Hi-Fi Products
Service Bulletin

Model: D-15

No. 39

Subject: Portable Disc Player

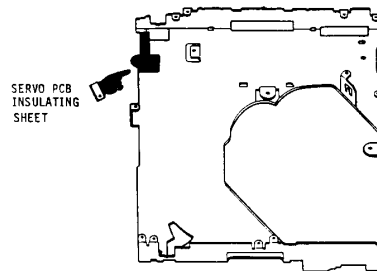
Symptom:
(51)

PCB shorts to the chassis.

Please add an insulating sheet to the servo PCB as shown.

Description	Part Number
Servo PCB Insulating Sheet	4-926-105-01
